February 5, 1996

Subject: LaSalle County Nuclear Power Station Units 1 and 2
ComEd Response to NRC Staff Request for Additional Information (RAI)
Regarding the Main Steamline Isolation Valve (MSIV) Leakage Control System
(LCS) Alternate Leakage Treatment (ALT) Path
NRC Docket Nos. 50-373 and 50-374

Responses to NRC Comments - Main Steamline Isolation Valve (MSIV)
Leakage Control System (LCS) Alternate Leakage Treatment (ALT) Path

ISOMETRIC VIEW OF LEAKAGE CONTROL PATH
 UNIT 2 SHOWN (UNIT 1 IS MIRROR IMAGE)
 ATTACHMENT 2-1

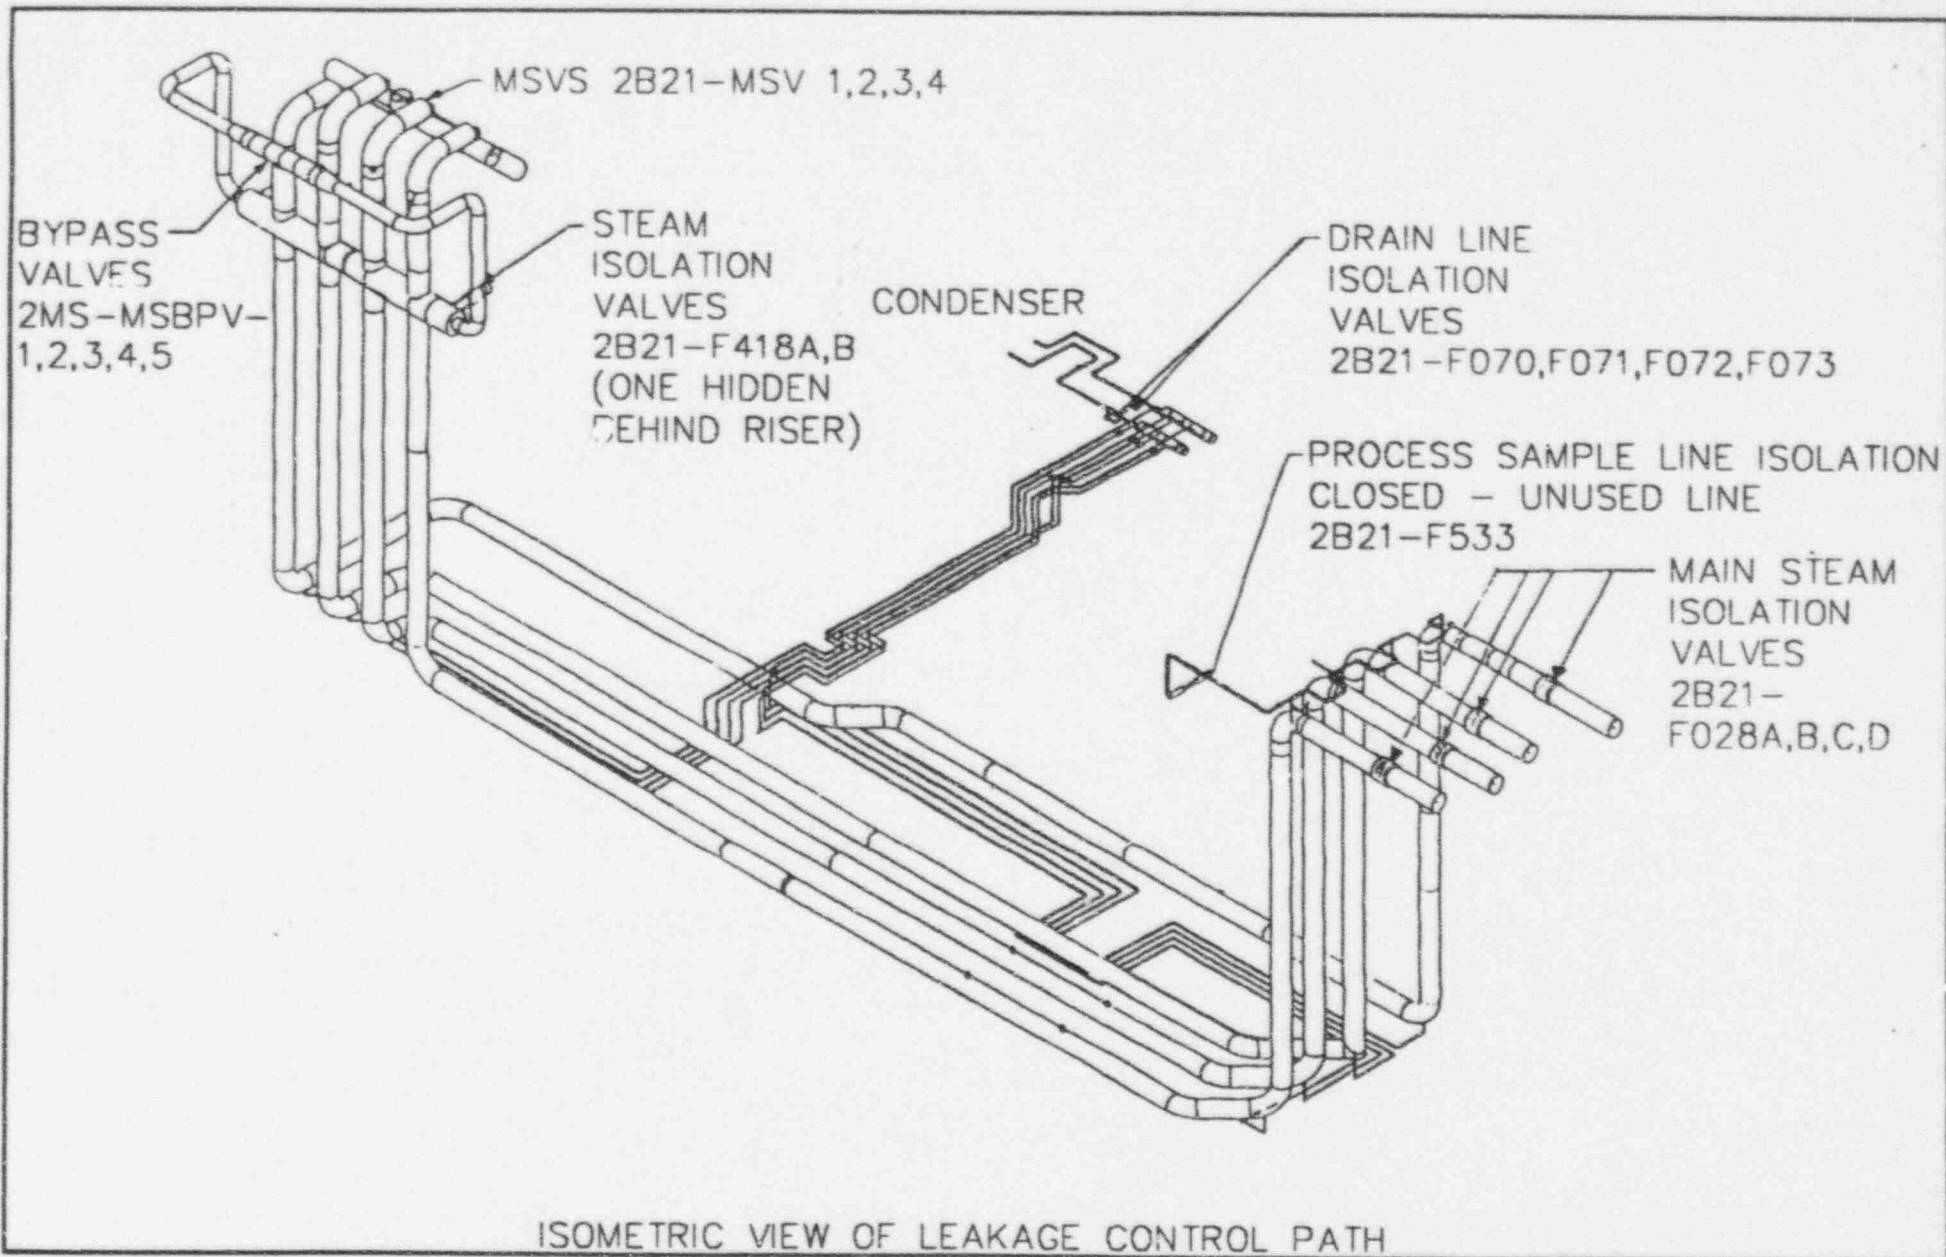
Provide a clear description of the MSIV alternate leakage treatment (ALT) path and indicate which portions you take credit for in your radiological dose model. Provide assurance of the reliability of the entire ALT path, including all of its boundary valves. Additionally, state whether all the motor-operated valves which are a part of the ALT path will be included in the plant IST program.

As shown in "Isometric View of Leakage Control Path and Boundaries" and the "Alternate Leakage Treatment Path Functional Diagram", Attachments 2-1 and 2-2 of this submittal, leakage through the outboard MSIVs [1(2)B21-F028A,B,C,D] is contained by the closed isolation valves identified on the "Alternate Leakage Treatment Path Boundary and Control Valves" table, Attachment 2-3.

Leakage from the outboard MSIVs travels down the four 26" main steam lines to either the upstream drain line (Primary ALT Path A) or to the downstream drain line (Primary ALT Path B) into the main condenser and out of the LP Turbine seals.

LASALLE
 CONDENSER
 ATTACHMENT 5-1

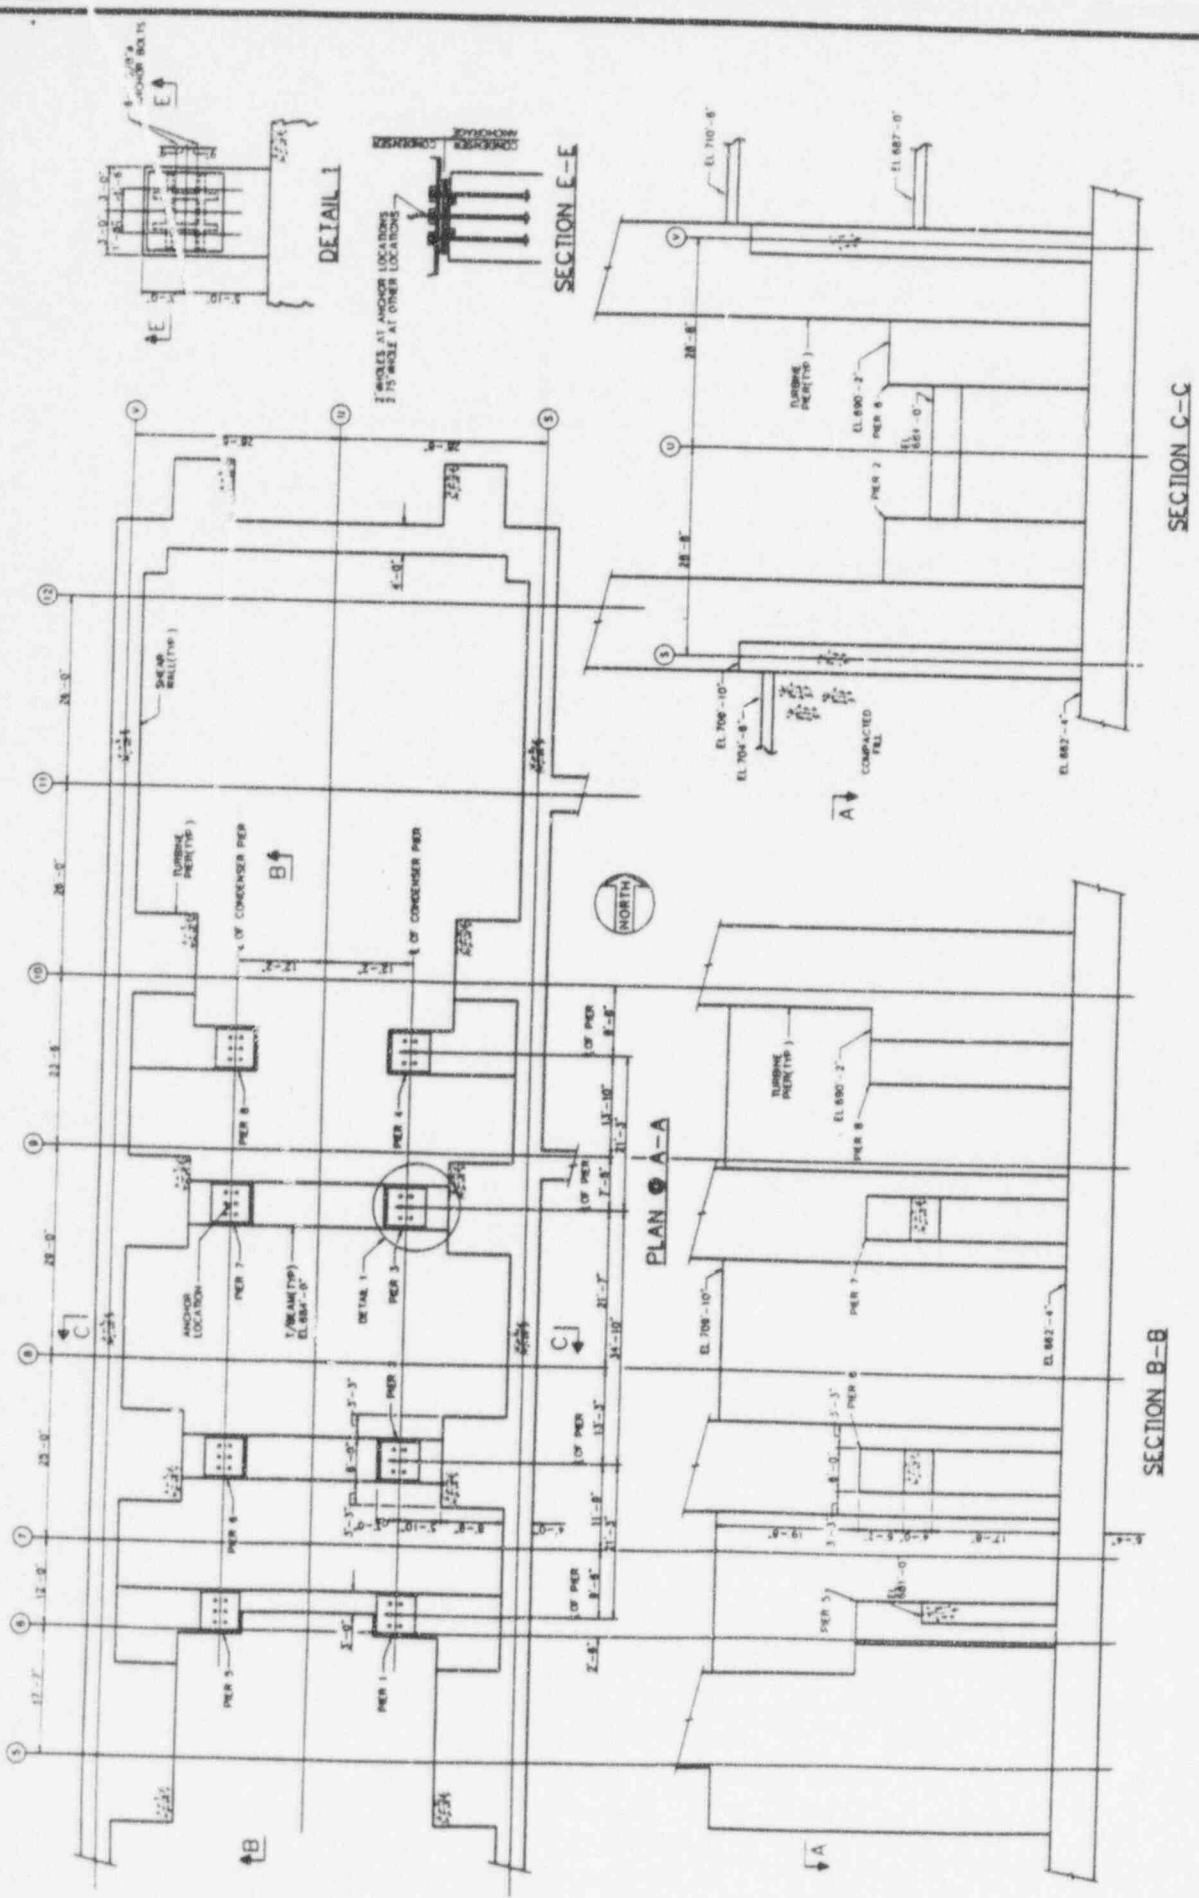
Provide an evaluation demonstrating that the structural components of the condenser are seismically adequate. The potentially significant adverse effects due to components of the condenser impacting on the adjacent foundation piers should also be addressed and resolved.

The hot well contains horizontal and vertical baffles. The circulating water flow is 617,000 gpm. The total effective surface area of the 40,462 tubes is 950,000 square feet. The overall dimensions of the condenser is 70' high, 35' wide, and 90' long (tube length). See Attachment 5-1 for an isometric view.

PLAN (TURBINE BUILDING ROOF)
 (N.T.S.)

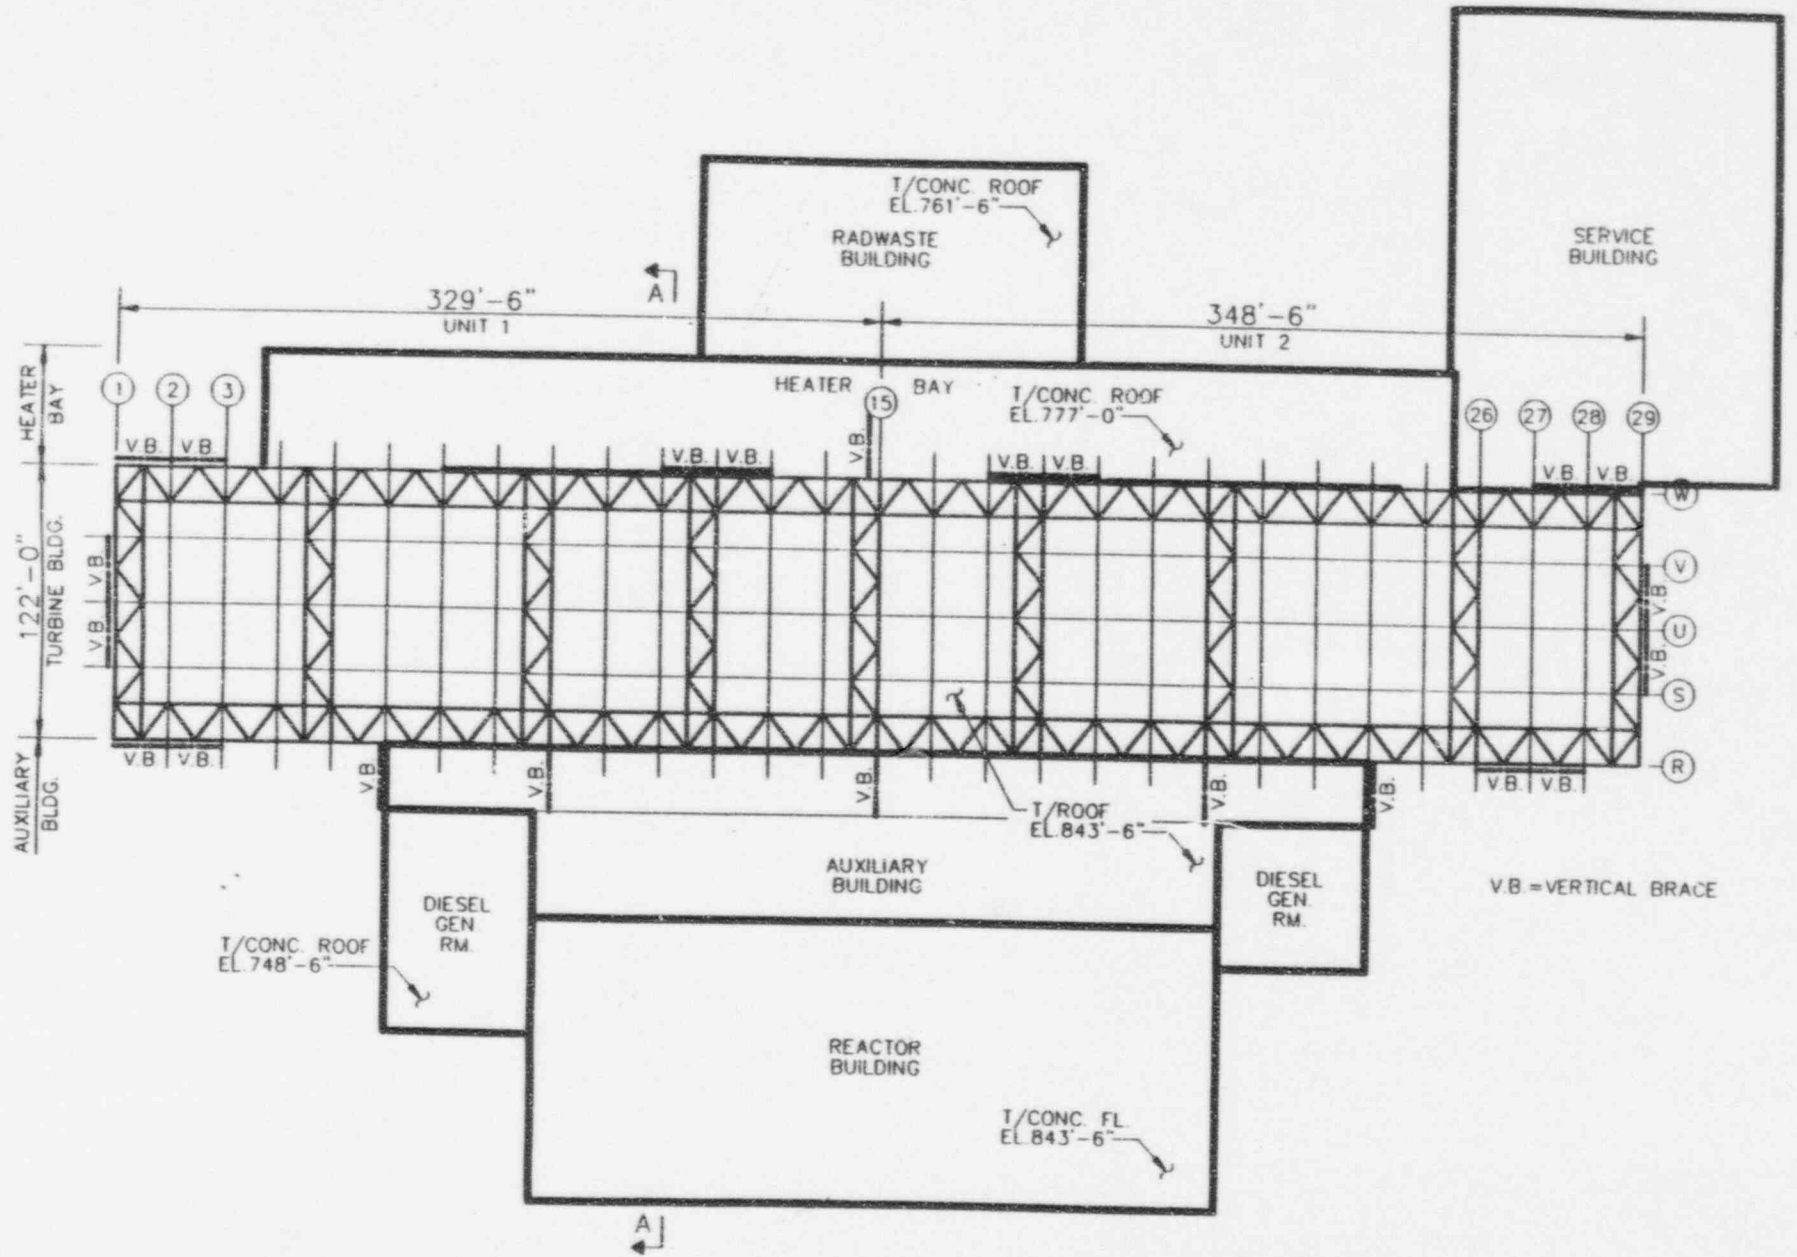
Provide an evaluation demonstrating that the Turbine Building roof structure remains elastic under SSE conditions.

The Turbine Building is an integral part of the plant seismic model for LaSalle. The Turbine Building is a 678'-0" long, 122'-0" wide and 75'-6" high (above main floor) structure (Units 1 and 2 combined) located between the Auxiliary/Diesel Generator Buildings (both Category I structures) to the East and the heater bay and radwaste structure to the West. The Turbine Building roof is in continuation of the Auxiliary Building roof (Elevation 843'-6"). This roofing system is ultimately connected to the Reactor Building refueling floor which is a very stiff concrete slab diaphragm. (See Attachments 8-1 and 8-2.)

122'-0" in the E-W direction. Nine horizontal roof trusses spanning 122'-0" in the east/west direction have been installed to transfer north/south horizontal loads to Column Rows 'R' and 'W'. Additionally, a horizontal truss system has been installed along the entire periphery of the roof structure to transfer the north/south and east/west horizontal loads. Along Column Line 'R', which is a common wall for the Turbine Building and the Auxiliary Building, there is a concrete shear wall from the basemat to the roof level. The vertical bracing system supporting the roof horizontal bracing system is as follows. (See Attachment 8-1.)
